CONSTRUCTION TRAFFIC MANAGEMENT PLAN

Sydney Metro West – Western Tunnelling Package

Unwin St Southern Tie In

Document Reference #: SMWSTWTP-GLO-CLJ-TF-PLN-000007

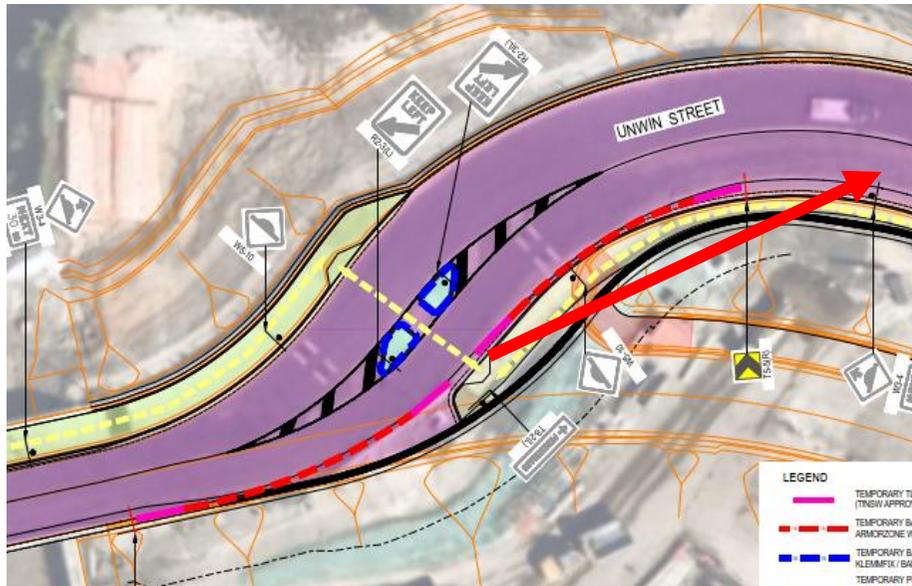
No.	Location	Description of Deficiency / Observation	Risk level
1	Unwin Street, southern pedestrian refuge	<p>The crossing point includes barriers, and a pedestrian path with permanent works. The arrangement suggests works will be undertaken between the pedestrian ramp and the approaching traffic.</p> <p>It is unclear if pedestrians will be able to see oncoming traffic, to be able to pick an opportunity to safely cross the road. It is also unclear if any gawk or screening will be around the works, and obstructing visibility.</p> <p>Compromised visibility for pedestrians may result in an increased probability of a pedestrian and vehicle incident. It is noted that the volume of pedestrians at this site has been observed to be quite low, and operating speed is also quite low. This is reflected in the risk rating.</p>	<p>Likelihood – Rare</p> <p>Severity – Moderate</p> <p>Risk Rating – Low</p>

Item	Reference	Comment	Client's Response/Action for Resolution	Close out Date
1	Unwin Street, southern pedestrian refuge	The crossing point includes barriers, and a pedestrian path with permanent works. The arrangement suggests works will be undertaken between the pedestrian ramp and the approaching traffic. It is unclear if pedestrians will be able to see oncoming traffic, to be able to pick an opportunity to safely cross the road. It is also unclear if any gawk or screening will be around the works, and obstructing visibility. Compromised visibility for pedestrians may result in an increased probability of a pedestrian and vehicle incident. It is noted that the volume of pedestrians at this site has been observed to be quite low, and operating speed is also quite low. This is reflected in the risk rating.	When all works is occurring traffic controllers will be in place to assist and guide pedestrians. Traffic will be stopped and pedestrians escorted across road. No gawk screens will be implemented. Pedestrian activity and sight lines will be monitored and checked each shift	06.12.2024

2 Unwin Street, southern pedestrian refuge

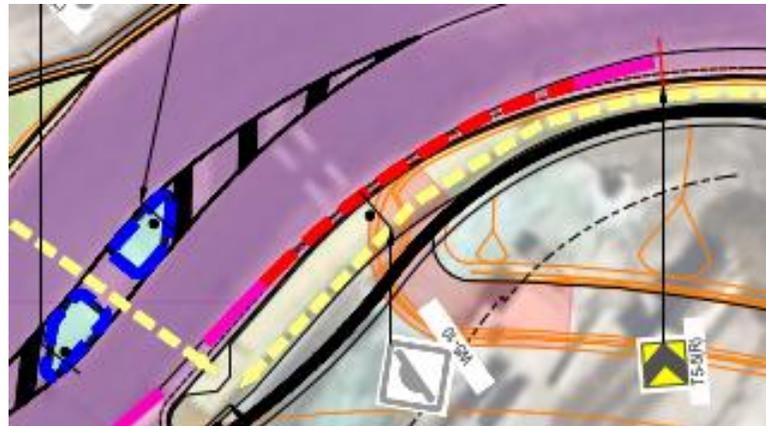
There are barriers proposed around the bend, and adjacent the works area. These barriers are proposed to be waterfilled armorzone barriers. These barriers appear to be in very short lengths.

These barriers do not achieve the minimum installation length for reliable deflection areas, nor do they provide suitable length of need for reliable deflection.

Although it is understood some barriers may be used as delineation devices at times, this may provide a false sense of security to workers, and result in an increased likelihood of a run-off road incident impacting the barriers and works or workers.

2	Unwin Street, southern pedestrian refuge	There are barriers proposed around the bend, and adjacent the works area. These barriers are proposed to be waterfilled armorzone barriers. These barriers appear to be in very short lengths. These barriers do not achieve the minimum installation length for reliable deflection areas, nor do they provide suitable length of need for reliable deflection. Although it is understood some barriers may be used as delineation devices at times, this may provide a false sense of security to workers, and result in an increased likelihood of a run-off road incident impacting the barriers and works or workers. Should a clear area be intended behind the barriers, it is not clear how this is being delineated on site, or if the barriers are intended to protect any works or excavations.	All works will be conducted under lane closure. Barriers will be placed into position at end of each shift to protect work area only and to maintain existing pedestrian pathway. Any excavations will be outside of clearzone or be filled as required.	06.12.2024
